# TOWN OF CORTLANDT PLANNING BOARD

**MEETING AGENDA.....PLANNING BOARD**  
**TOWN OF CORTLANDT**  
**6:30 TUESDAY EVENING\***  
**OCTOBER 1, 2024**

**PB 2024-1** a. Public Hearing: Application of KPB Properties LLC for Site Development Plan approval and a referral from the Town Board of a Petition for a Zoning Text Amendment for a proposed 4-story, 75,000 sq. ft. self-storage facility located at 3 Locust Avenue. Drawings latest revised September 24, 2024.

PROJECT NAME: **PROPOSED SELF-STORAGE FACILITY**  
3 LOCUST AVENUE  
CORTLANDT MANOR, NY 10567  
COUNTY OF WESTCHESTER  
SECT.: 34.5, BLOCK: 2, LOT: 6

DRAWING No.: **C-3**

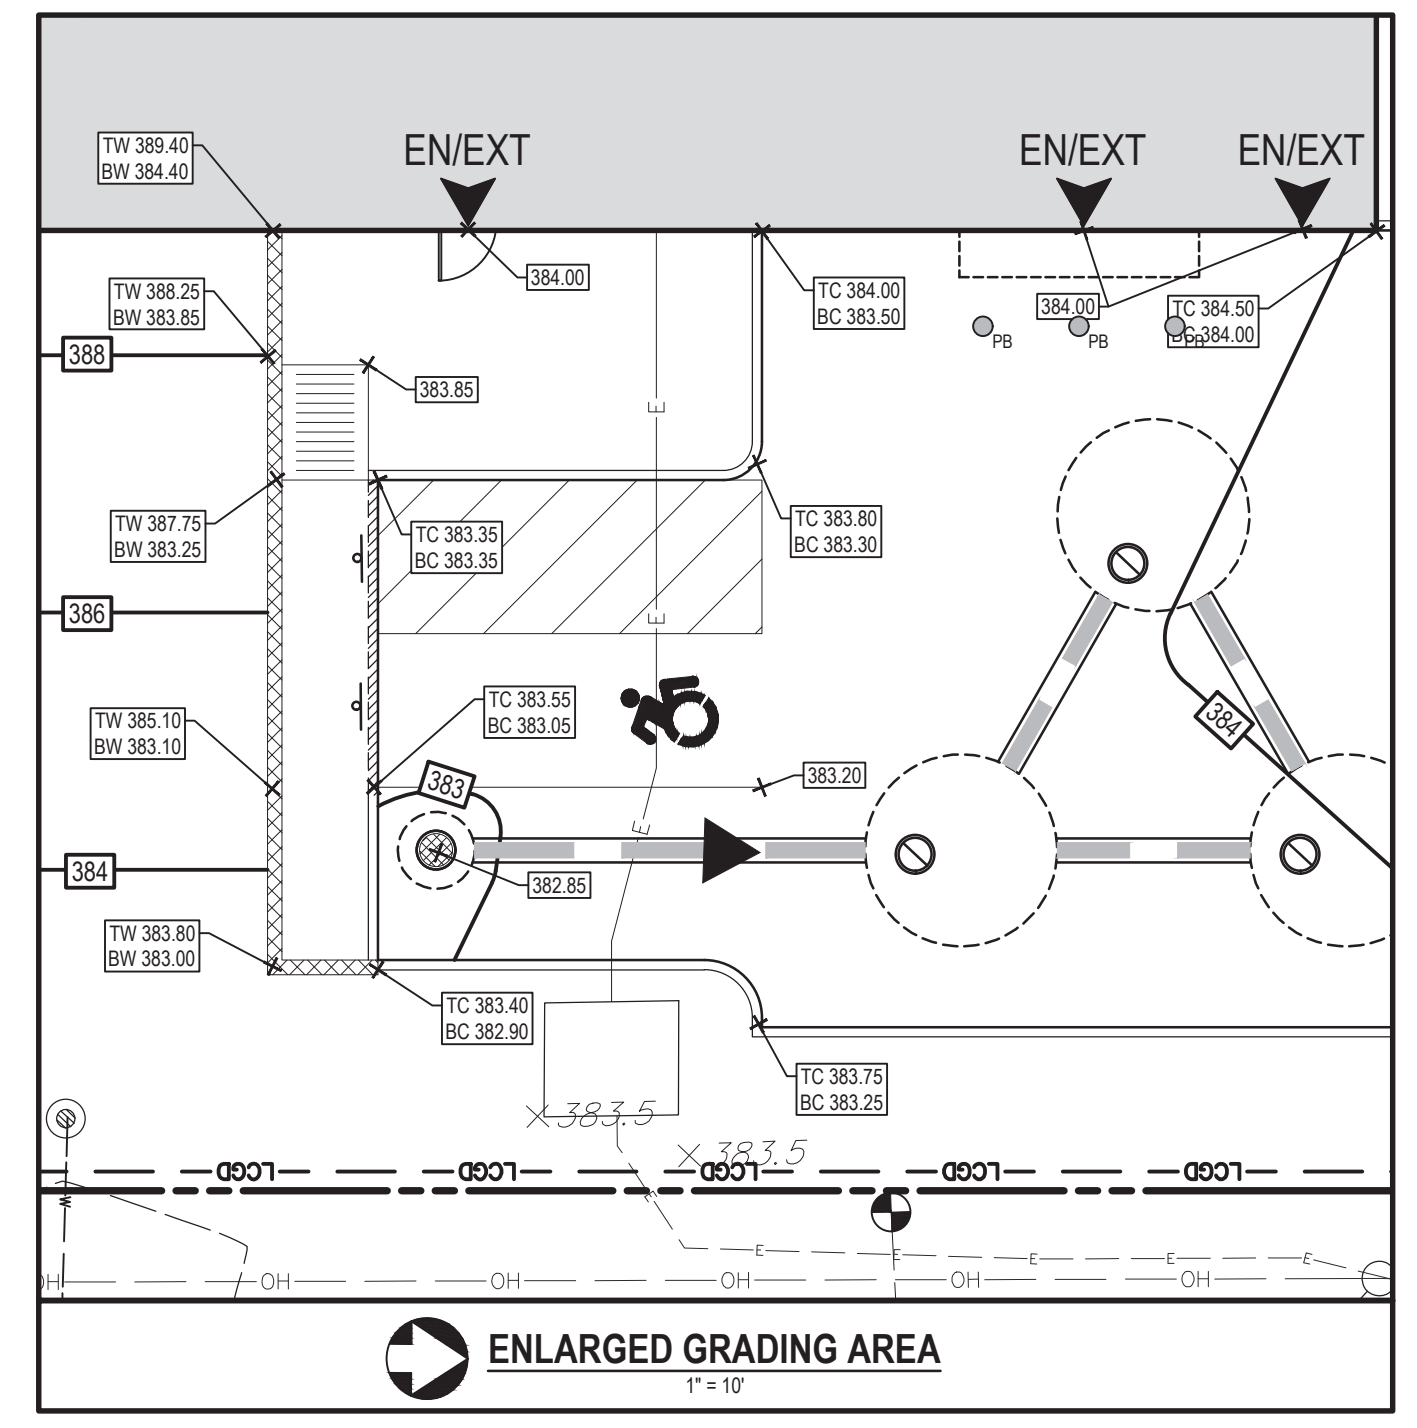
10. Sheet C-3: Are their roof leaders on the eastern side of the facility? If so, where do they discharge?

11. Sheet C-3: Outlet/overflow pipe shall be provided for drywells B-2:B-4.

12. Sheet C-3: Show locations and results of on-site test pits and fatting head tests associated with the on-site stormwater management system. Proper separation between the bottom of drywell system to ground water and bedrock cannot be confirmed without requested results.

13. Sheet C-3: Provide pre-treatment measures (including calculations in drainage report) prior to discharging runoff into dry welts.

14. Sheet C-3: It is unclear where the existing on-site drainage structure located on the southern side of the site discharges too. This should be investigated and depicted on the plans.

15. Sheet C-3: Proposed fence is set back three feet from retaining wall along the along access drive. Detail on Sheet C-4 should be updated to reflect fence post location and how geogrid will be placed around the post.

1. Sheet C-3: Drywell systems should be designed offline. Provide upstream bypass for both systems.

7. The sizing information provided in the HydroCAD model for Drywell System A does not match the information provided on sheet C-3 of the plant set. Revise the HydroCAD model to be consistent with the plans.

**Response: The test pit locations have been added to sheet C-3, along with a table of the results for the same.**

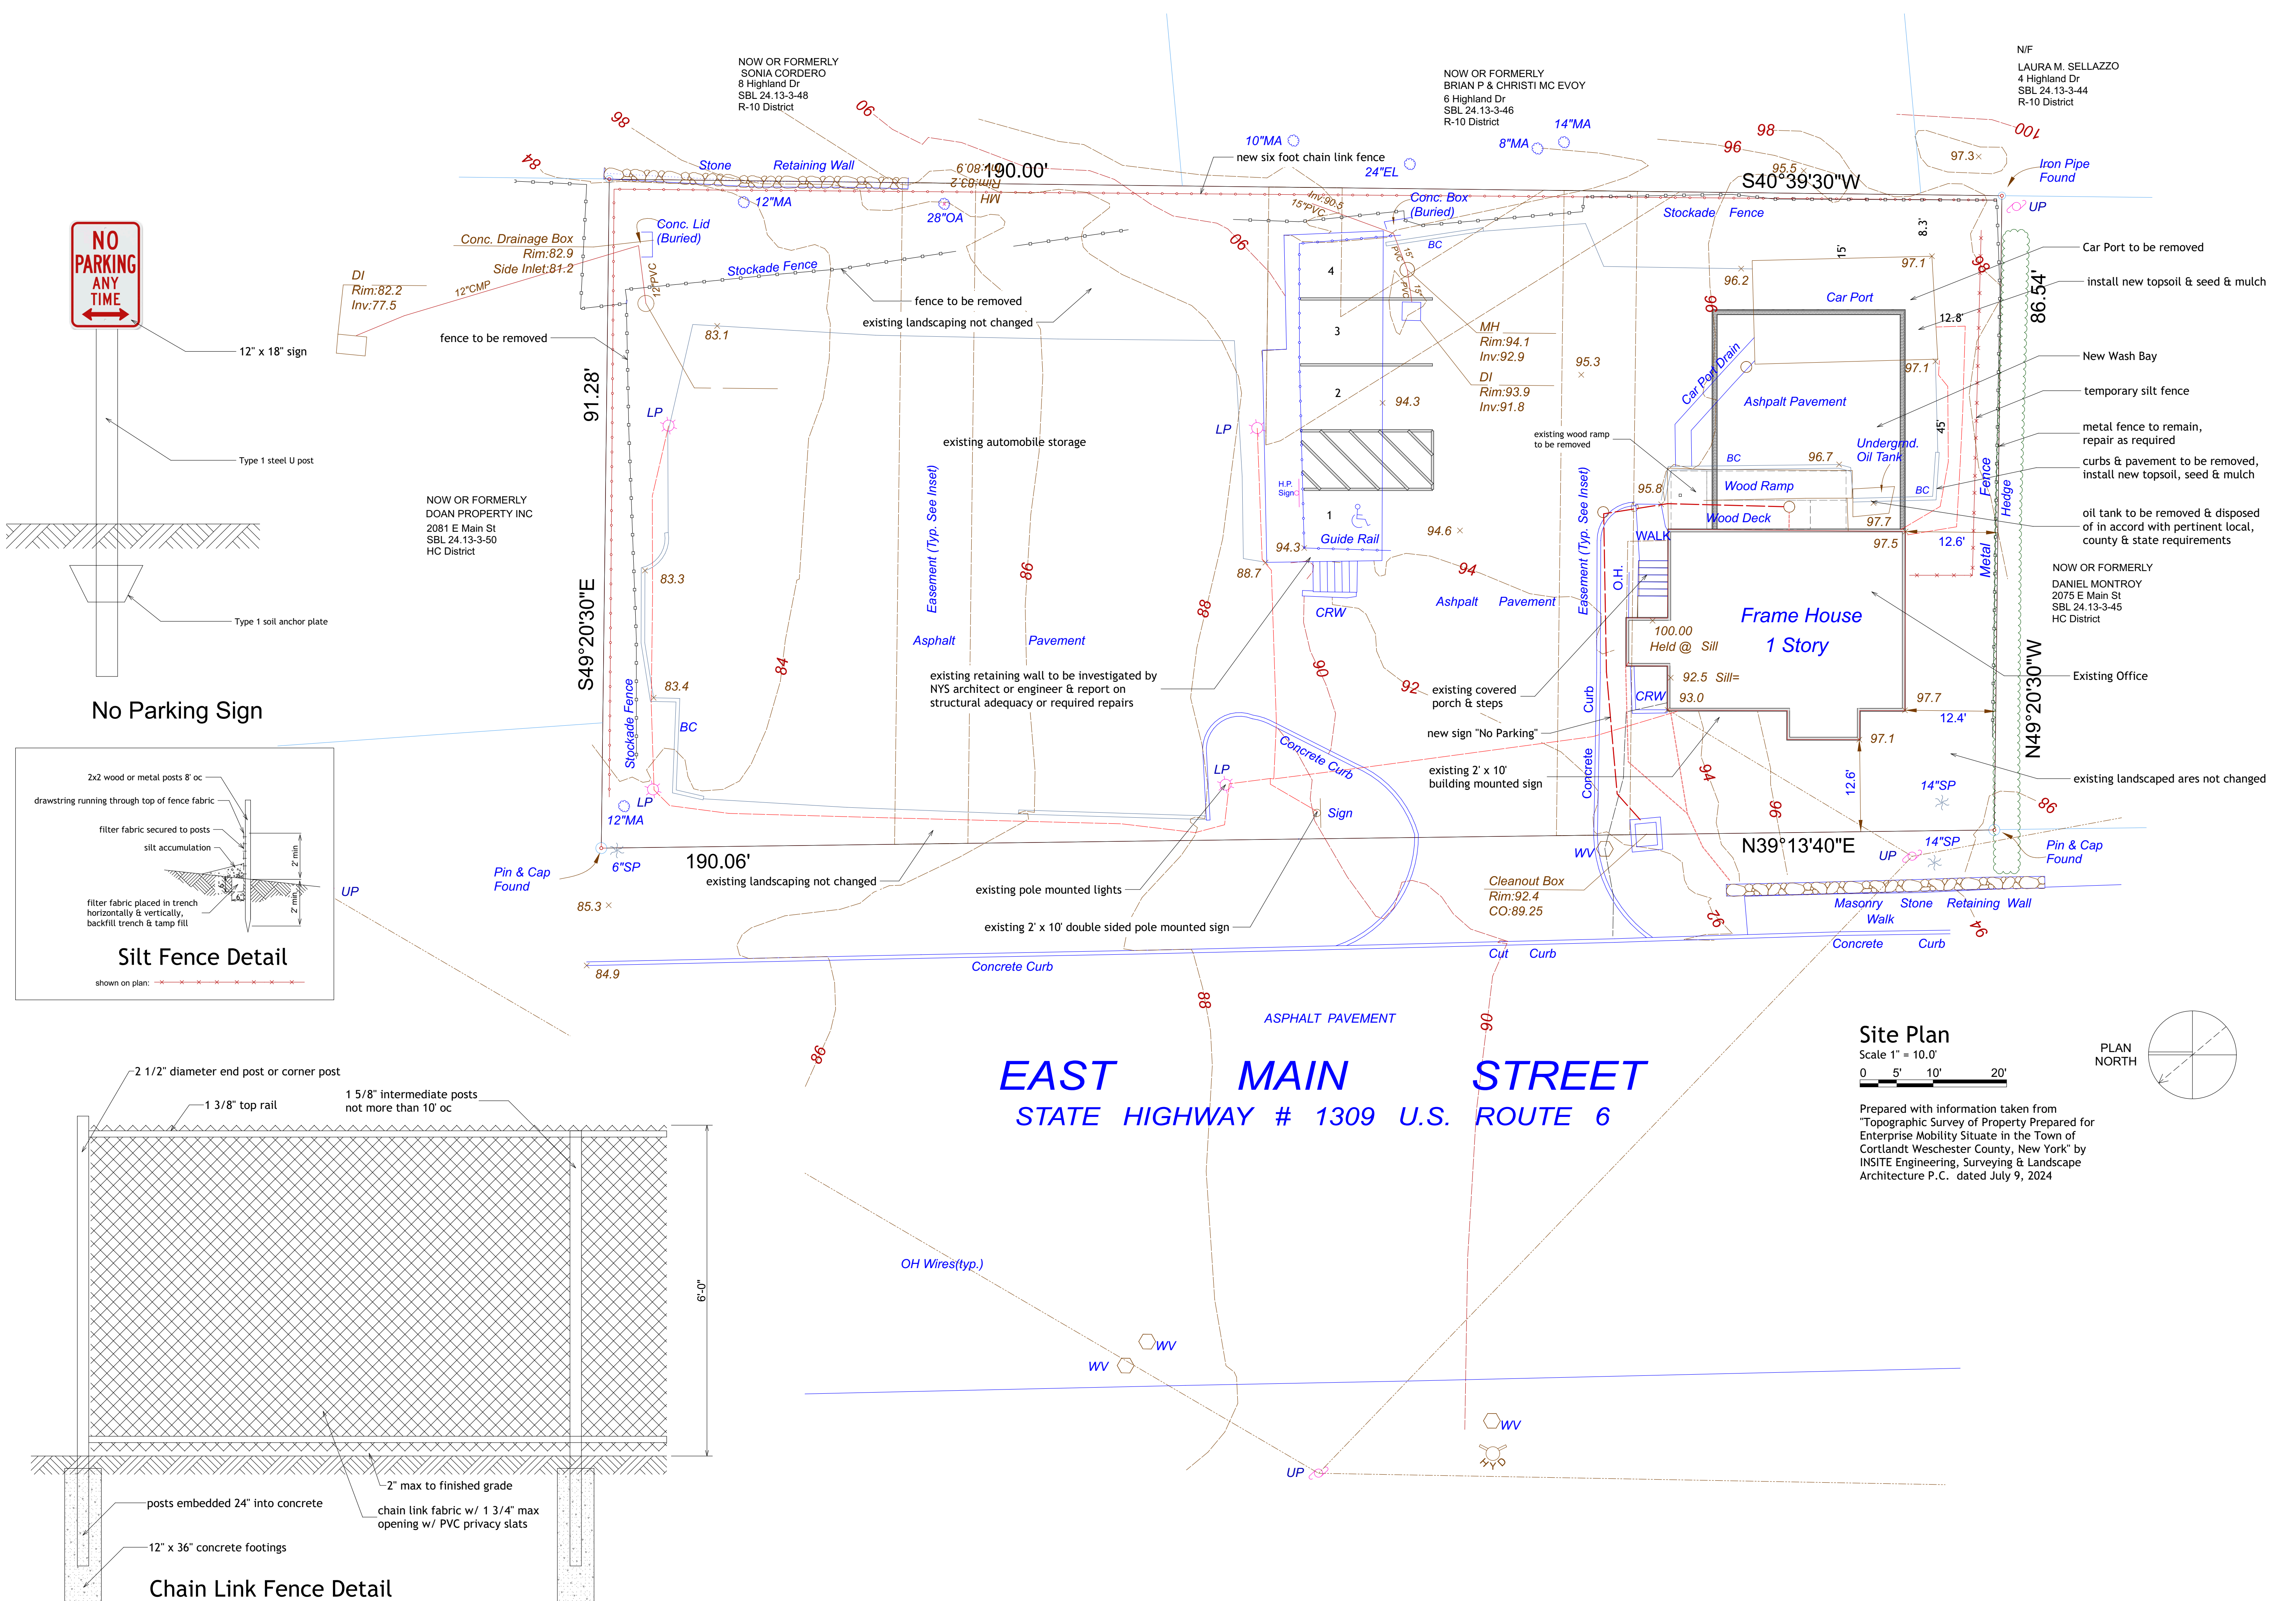
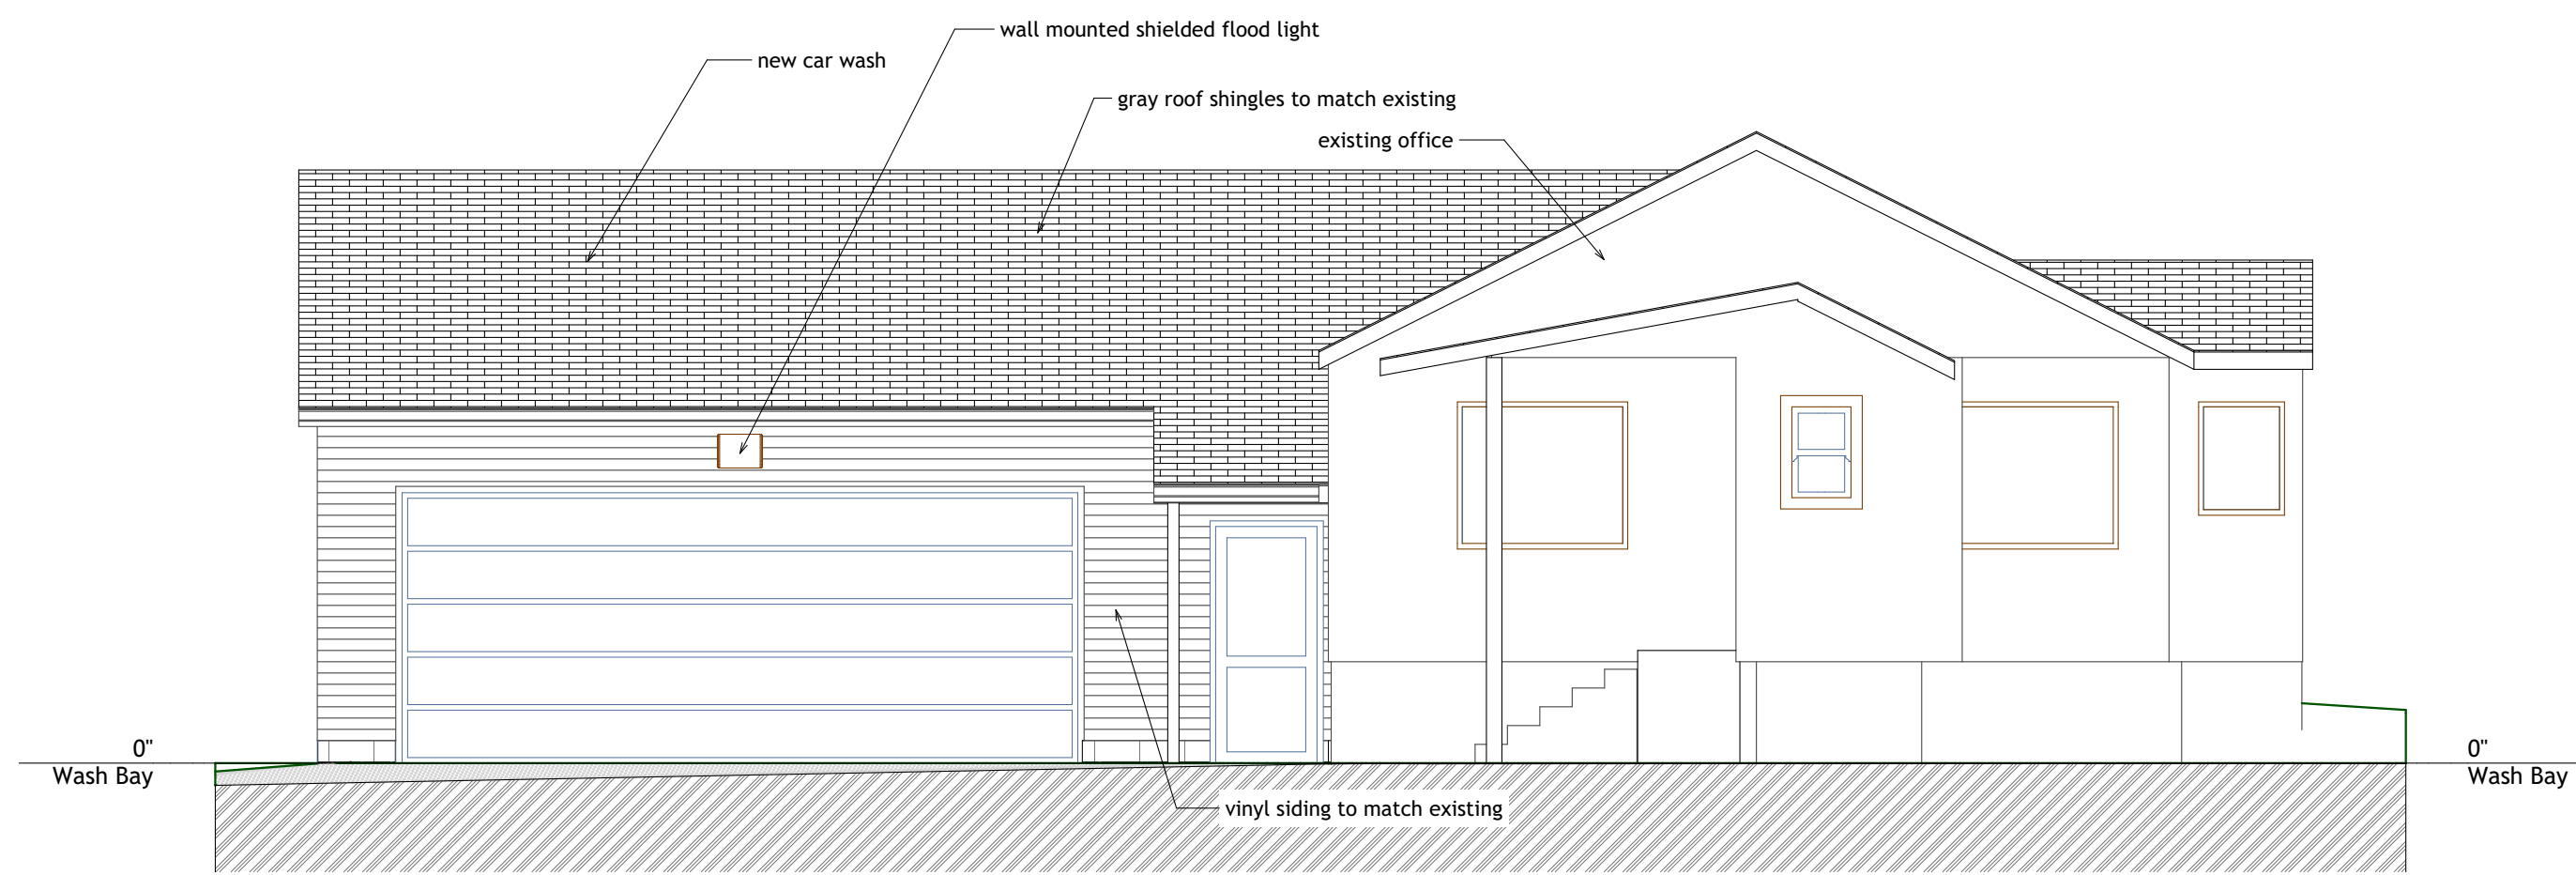
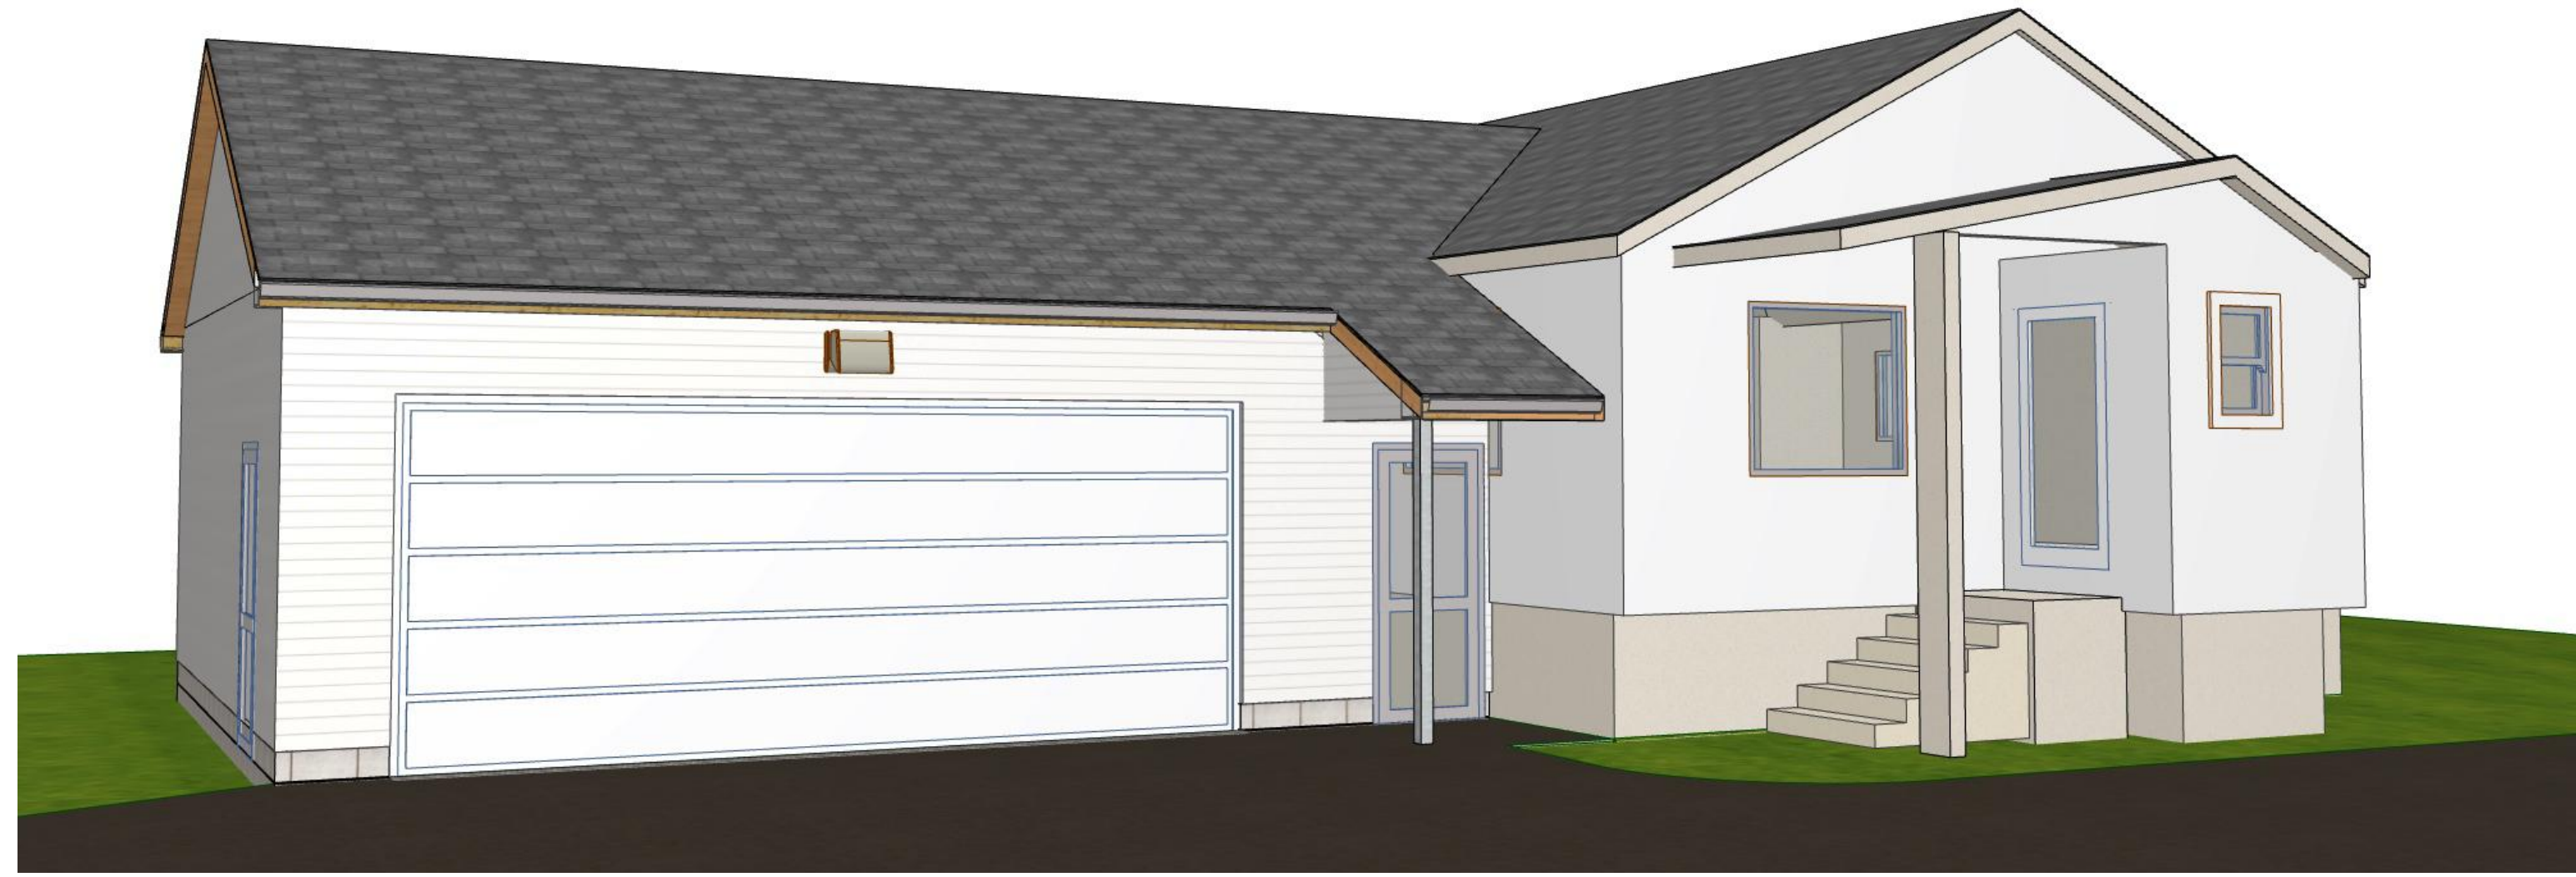
1. Sheet 1 of 2: Please provide parking requirements for the existing use.
2. Sheet 1 of 2: Please provide a tree protection detail and delineate the trees to be protected during construction.
3. Sheet 1 of 2: Existing asphalt is located within the confines of the existing car port to be removed. Please identify asphalt to be removed and revegetated with topsoil, seed, and mulch.
4. Sheet 1 of 2: Where will the discharge from the wash bay be conveyed to?
5. Sheet 1 of 2: Please provide the following notes:
  - a. The applicant is aware that the disturbed areas shall be 100% stabilized and

6. Sheet 1 of 2: Sections of the existing on-site stockade fence are dilapidated and toppling over. Due to the age and intentions of the fence to serve as screen to the residential buffer, it is recommended the Planning Board request the on-site fencing be replaced.

7. Sheet 1 of 2: Please provide a tax identification number of the parcel.
  8. Sheet 1 of 2: There is an existing underground tank in the vicinity of the proposed addition. Please provide procedures for the safe removal and disposal of the tank in accordance with local, county, and state laws.

9. Sheet 1 of 2: Will temporary relocated parking be required for the 4-spaces adjacent to the office during the removal of the existing car port and construction of the new wash bay? If so, delineate the areas and provide an ADA route. If not provide the limits of disturbance on the plans and demonstrate adequate turning movements.

10. Sheet 1 of 2: There are cracks and deterioration of the existing concrete retaining wall where the stairs and wall join. Provide a letter from an licensed NYS architect or engineer, indicating they have inspected the entire wall, and it is structurally sound and capable of supporting loads imposed on it. Additionally, provide details for mitigating the existing wall.

11. Parking is currently taking place along the existing driveway (ingress side). Signs shall be provided prohibiting parking.
  12. Sheet 2 of 2: Depict proposed water connection for wash bay and provide design of backflow prevention device.
